CLEARFIELD CITY PLANNING COMMISSION MEETING AGENDA

STAFF REPORT

SUBJECT: Discussion and Possible Action on **SP 2023-0201**, a site plan approval request by Jarod Hall with Divelept Design for a three-story mixed use building at the subject property. **Location:** 246 East 200 South (TIN: 12-003-0042). **Parcel Area:** 0.33 Acres. **Zone:** U-C (Urban Core Commerce). **(Administrative Action).**

Project Information	
Project Name	246 UHB Mixed-Use
Site Location	246 East 200 South
Tax ID Number	12-003-0042
Applicant	Jarod Hall, Divelept Design
Owner	True Real Estate Holdings, LLC
Proposed Actions	Site Plan Review Approval
Current Zoning	U-C (Urban Core Commerce)
Site Area	0.33 Acres

SHEET NUMBER:
A.002
DIVELEPT DESIGN LLC © 2023

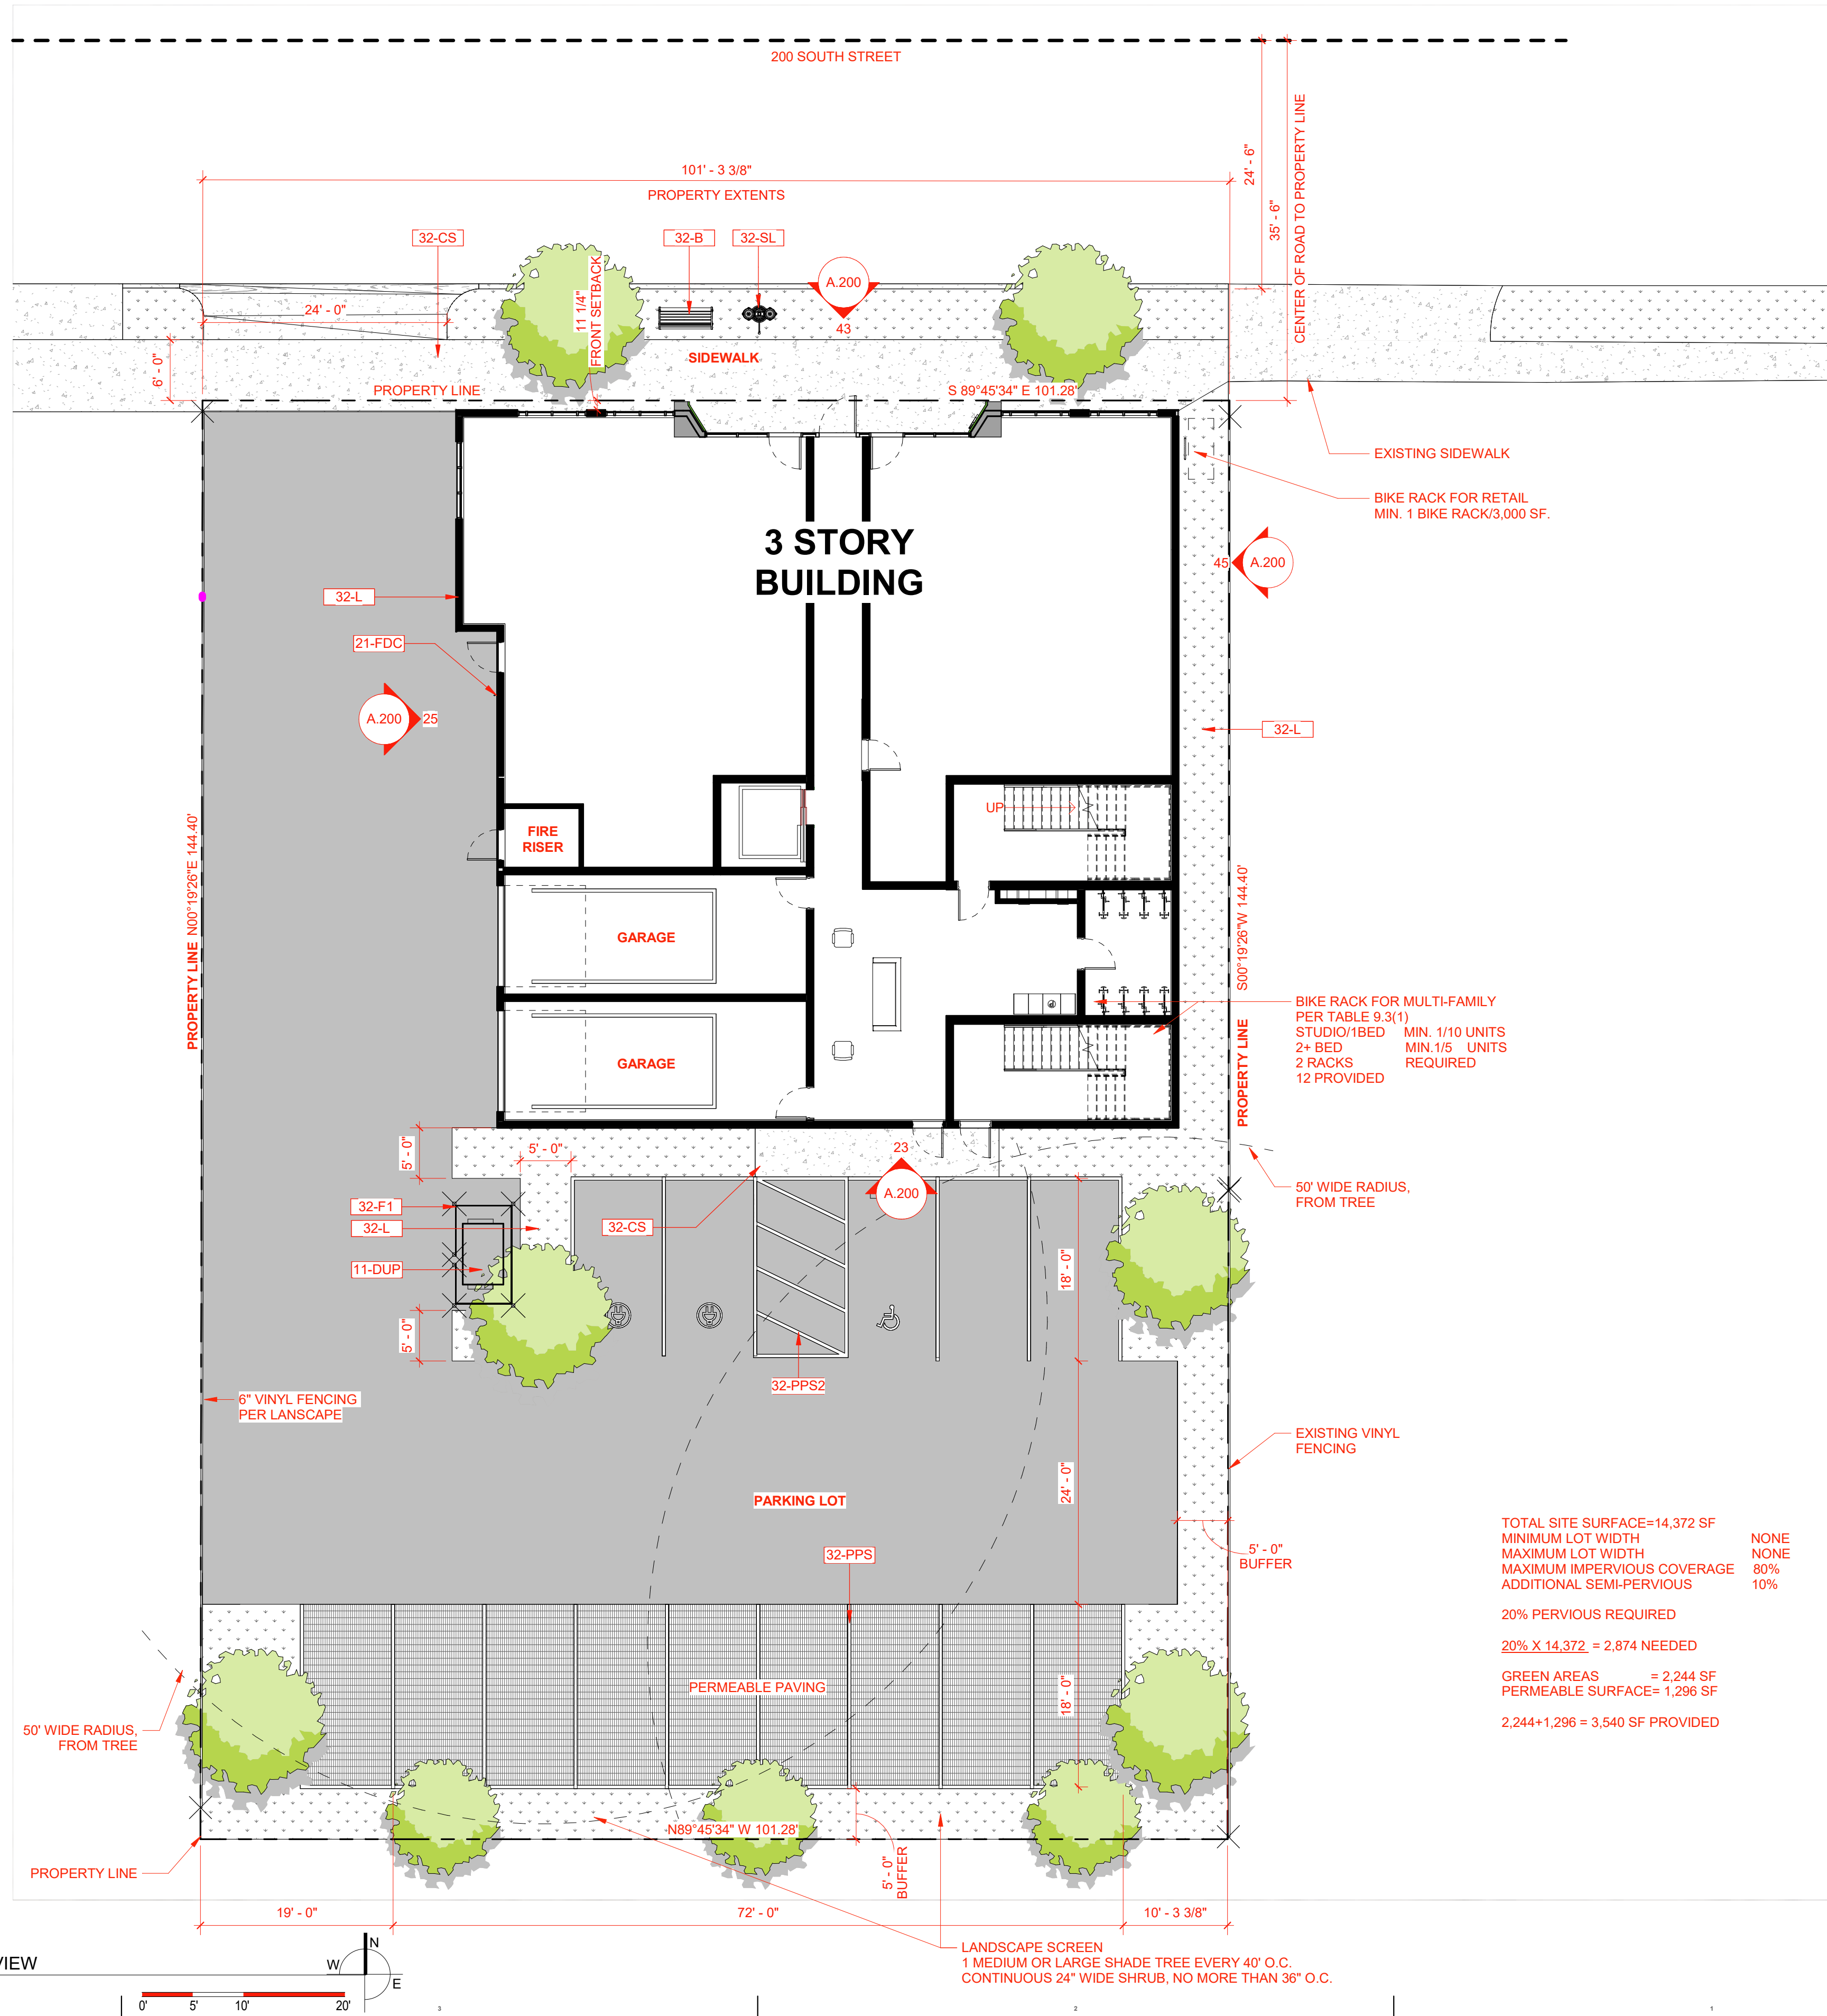
<i>Fencing</i>	Non-Compliance with FBC Staff Note: The plans show a new fence to be installed along the rear and west property lines. The plans will need to be revised to show fence heights. Fences shall be opaque and constructed of materials that complement the building. White vinyl only and chain link with slats are not allowed.

As outlined in Clearfield City Code Section 11-13-5 G “Snow Stacking Area”, “Every parking lot design shall plan for a snow stacking area to accommodate the stacking volume of a four-inch (4”) snow base over the entire parking lot.” The current plans indicate two different snow removal areas and the associated snow stacking areas. The civil site plan has a note calling out the installation of a snow melt system. If a snow melt system is proposed, details need to be included with the plans. If there won’t be a snow melt system, the note needs to be removed from the site plan.

- 1) The areas shown on the architectural site plan as permeable paving will need a detail added to the plans. The permeable paving will also need to be shown on the civil plan set.

- 11) The plans shall be revised to show fence heights. Fences shall be opaque and constructed of materials that complement the building. White Vinyl only and chain link with slats are not allowed.

- 12) The plans shall be revised to provide more detail for the snow melt system referenced on the civil plans, or to remove the note if no snow melt system is being proposed.
